ADDENDUM NO. 4

DATE: **July 19, 2016**
OWNER: **City of Stockbridge**
PROJECT: **Willow Springs & Southwinds Pump Station Rehabilitation**
C & S PROJECT NO.: **S9100.004 / RFP #201606-08**
ENGINEER: **Martin C. Boyd, P.E.**
CARTER & SLOOPE, INC.
P.O. Box 534
Watkinsville, Georgia 30677
Telephone: 706-769-4119 Fax: 706-769-4546
Email: mboyd@cartersloope.com

**CONTRACT A
SOUTHWINDS PUMP STATION SITE PLANS**

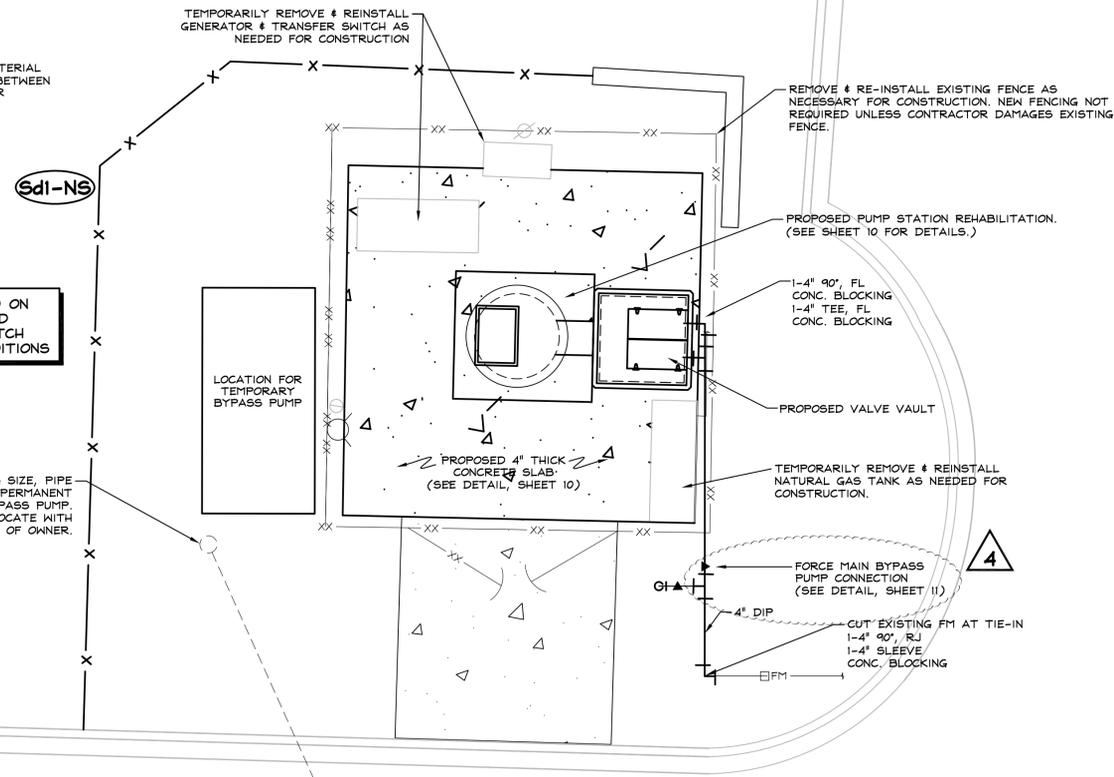
- B. Replace Sheet 8 with the revised attached sheet.
- C. Refer to Sheet 11:
 - a. Under the Protective Coatings paragraph, Note 5, change “TNEMEC Series 451” to read “TNEMEC Series 431”.
